Service Bulletin

Subject: Information on COAX Repair Kit Availability

Models: 2006-2016 GM Passenger Cars and Light Duty Trucks

COAX Cable Kits

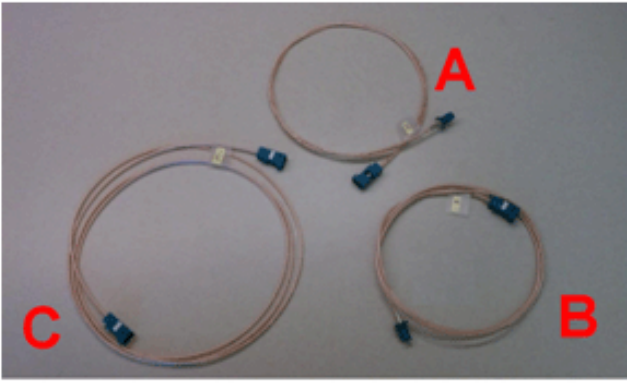
GM is implementing a new service strategy that uses a set of universal coaxial repair kits to service vehicles. This only applies to cable used for high frequency signals, such as cellular (OnStar®), satellite radio (XM) and GPS (navigation). The kits do NOT apply to the AM/FM cables.

There are four individual kits. Any given repair may require the use of one or more kits. Over time, stocking the original production coaxial cable will be phased out, and only the following kits will be used.

The following four kits are available for service:

Communication Interface Module Antenna Cable Kit (part number 13581174)

Consists of four different RG56 cables in lengths of 18 inches (A), 3.5 feet (B), 5 feet (C) and 7 feet (D). This kit is used to replace the cables for carrying a cellular signal or a combined cellular and GPS signal. It is also referred to as the long run cellular kit.

Digital Radio and Vehicle Locator Antenna Coaxial Cable Kit (part number 13581173)

Consists of three different RG316 cables in lengths of 3.5 feet (A), 5 feet (B) and 7 feet (C) and is used to replace the satellite radio and GPS cables. It is also referred to as the long run XM/GPS kit.

Digital Radio and Mobile Telephone and Vehicle Locator Antenna Coaxial Cable Kit (part number 19119056)

Consists of many different connectors, housings and jumpers to mate into the connector housings. This kit may be used by itself to repair a connector or in conjunction with either of the long run kits to change the connector ends. It is also referred to as the connections kit.

Communication Interface Module Antenna Cable Kit (part number 22803854)

Consists of a 4-inch jumper for the mini-UHF connector that was used on several OnStar modules before the 2011 model year.
